ADDENDUM CC-3

March 19, 2010

GILA COUNTY PUBLIC WORKS PROJECTS
GLOBE, ARIZONA

DLR GROUP PROJECT NOS. 30-09115-00 AND 30-09118-00
BID DOCUMENTS NO. 110109-1

Attachment No. M1
to Addendum No. CC-3
Dated: March 19, 2010

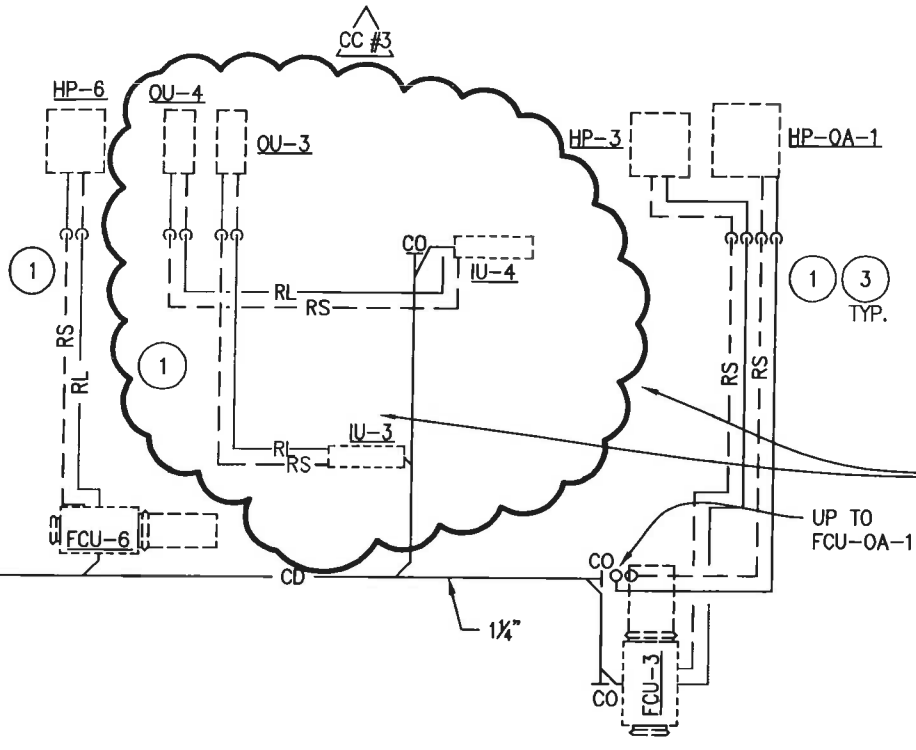
- a. Relocate IU-3 per Attachment M-1 to Addendum CC-3 dated March 19, 2010.

Attachment No. M2
to Addendum No. CC-3
Dated: March 19, 2010

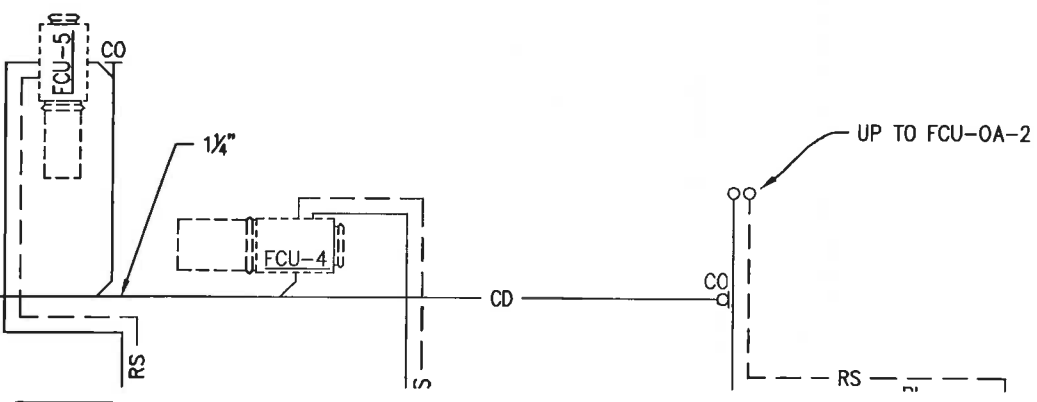
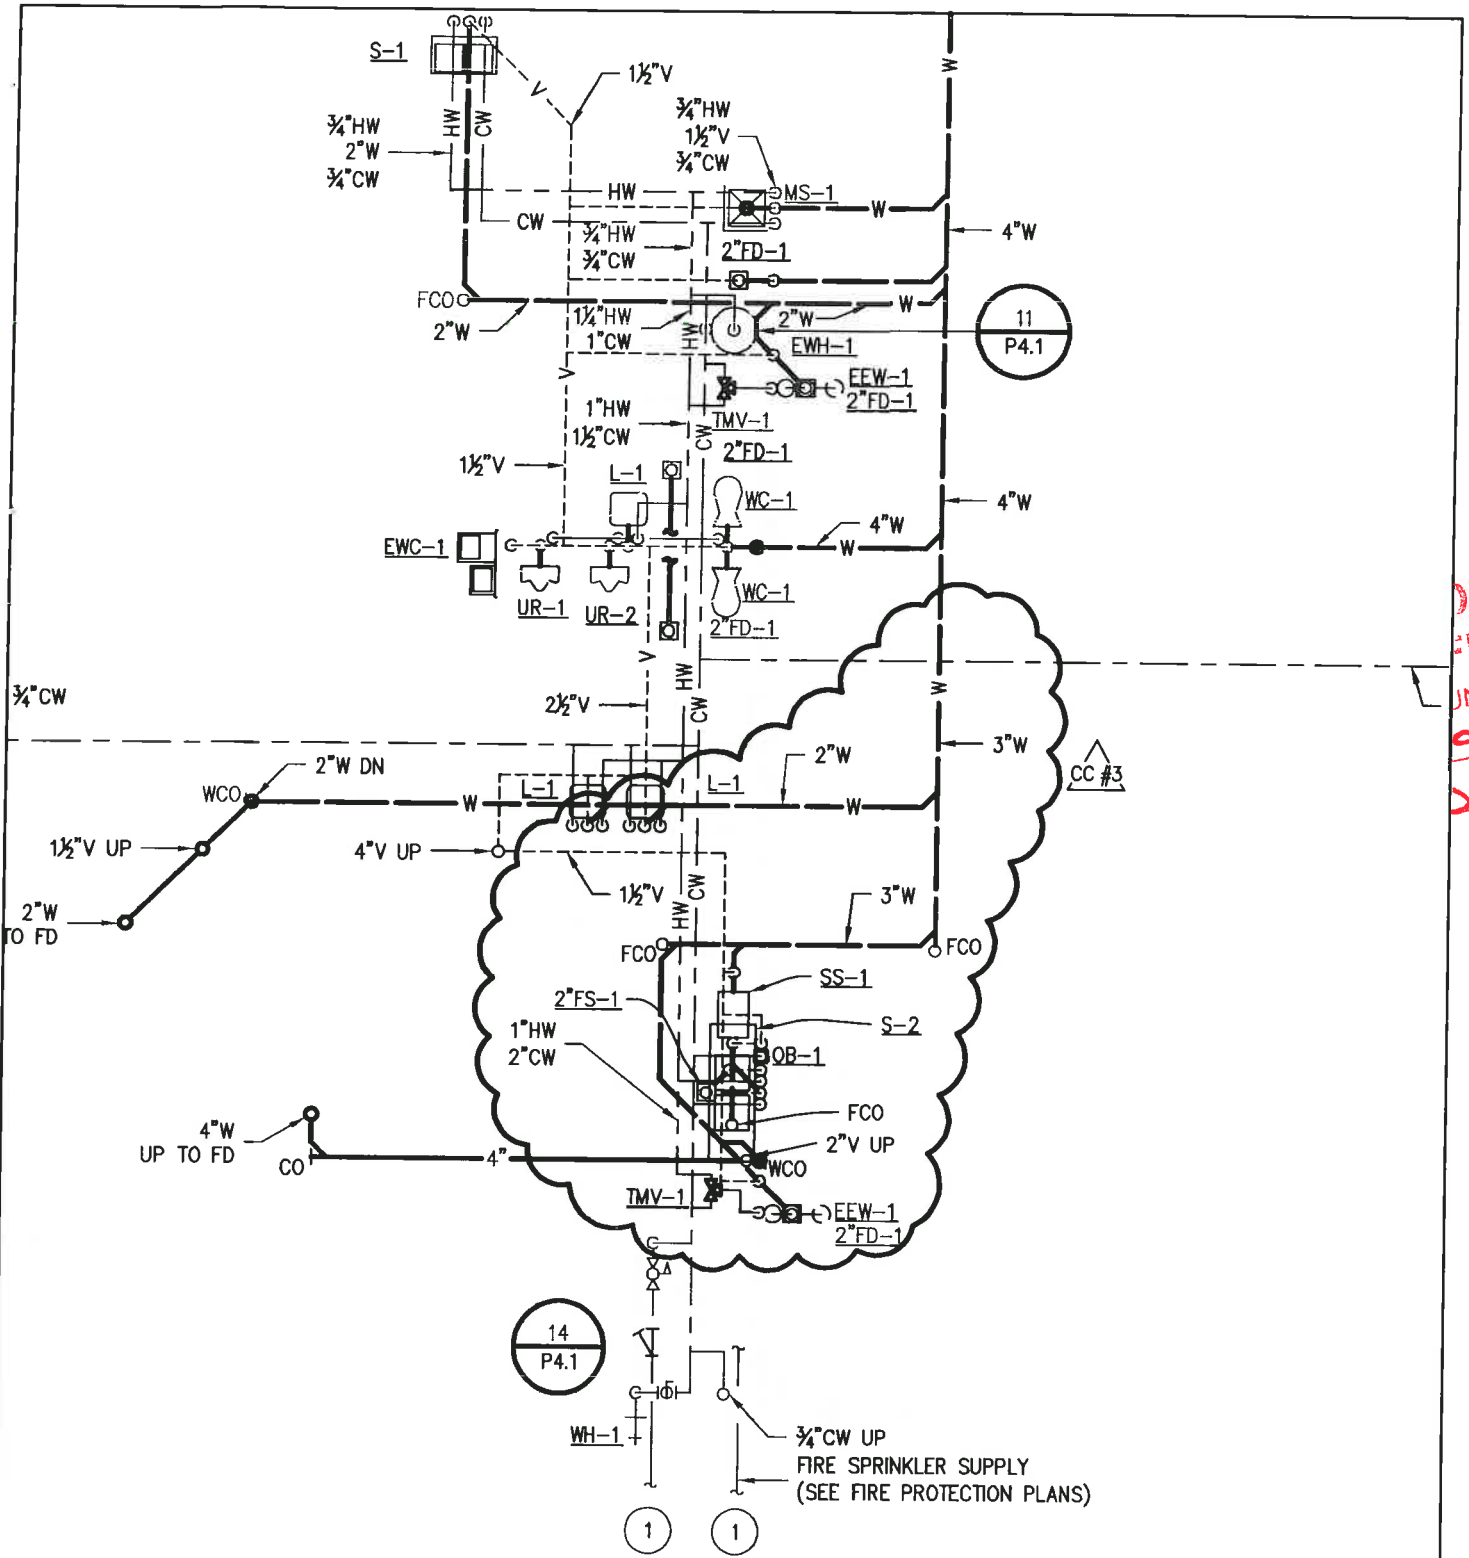
- a. Modify refrigerant and condensate piping per Attachment M-2 to Addendum CC-3 dated March 19, 2010.

Attachment No. M3
to Addendum No. CC-3
Dated: March 19, 2010

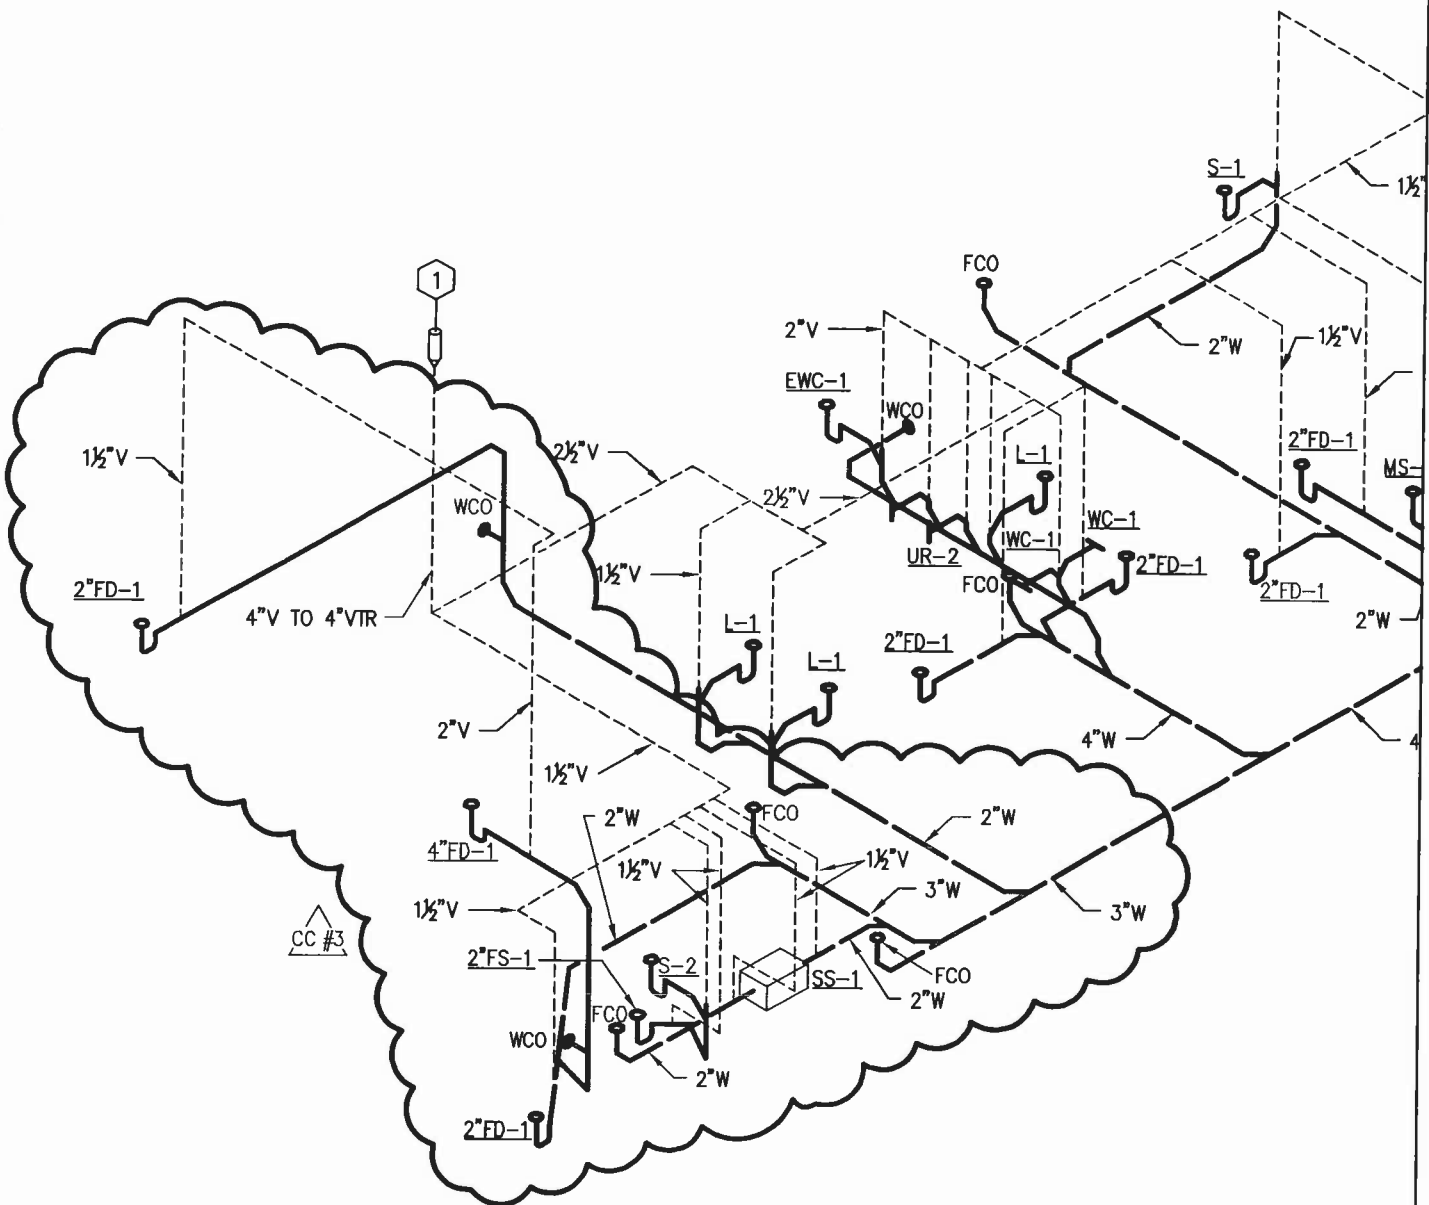
- a. Add S-2, SS-1, FS-1 and modify plumbing per Attachment M-3 to Addendum CC-3 dated March 19, 2010.

Attachment No. E3
 to ADDENDUM CC-3
 Dated: 19 March 2010

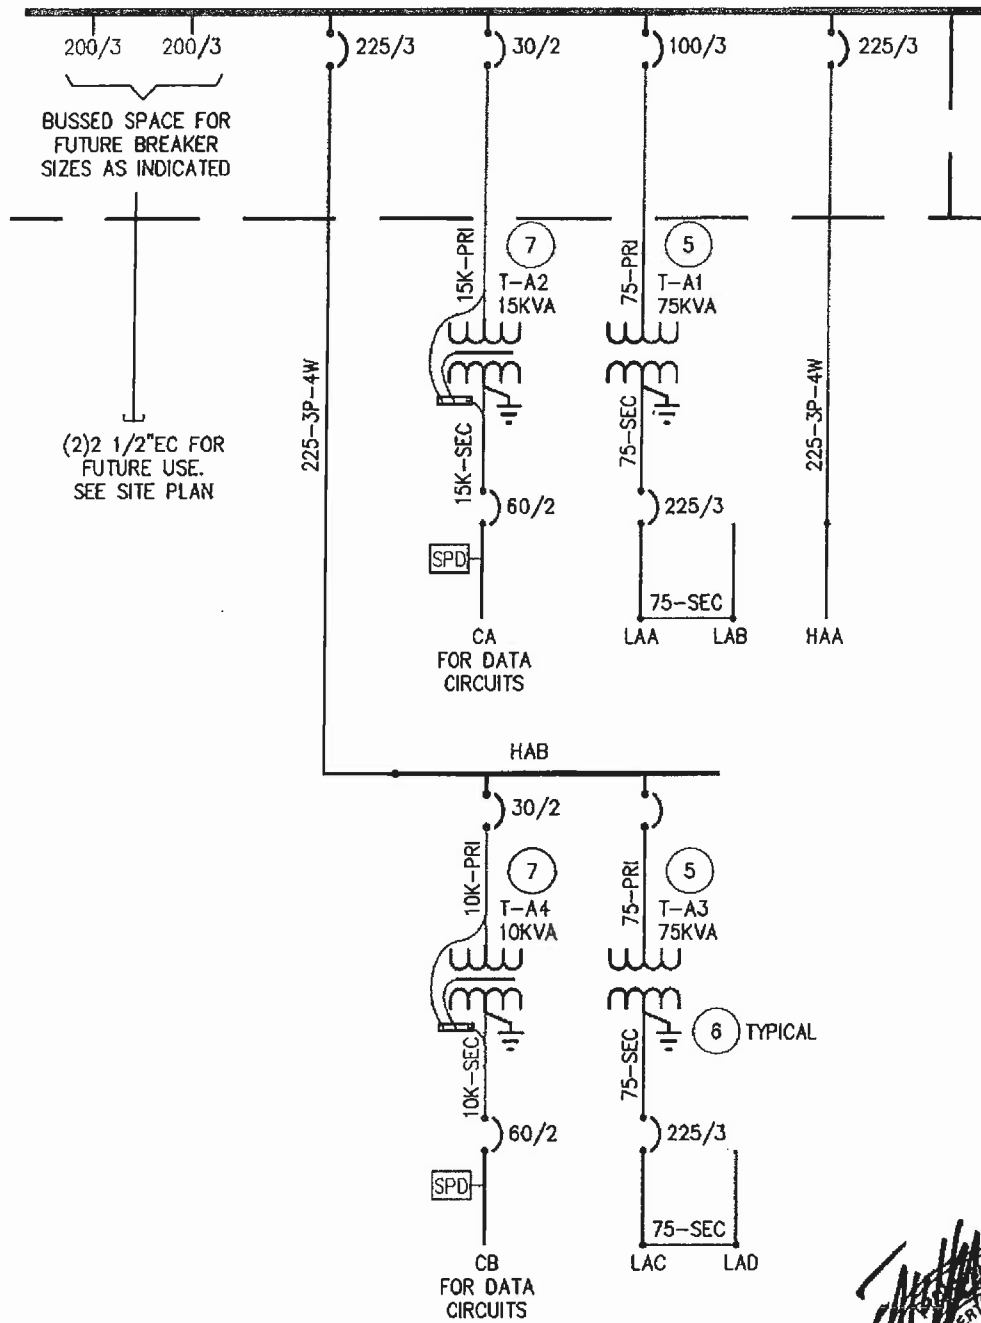
- a. From panel 'HAB' via transformers, delete the panel designations 'CF, LFA, LFB'. Add new designations 'CB, LAC, LAD' per Attachment E3 to Addendum CC-3 dated March 19, 2010.
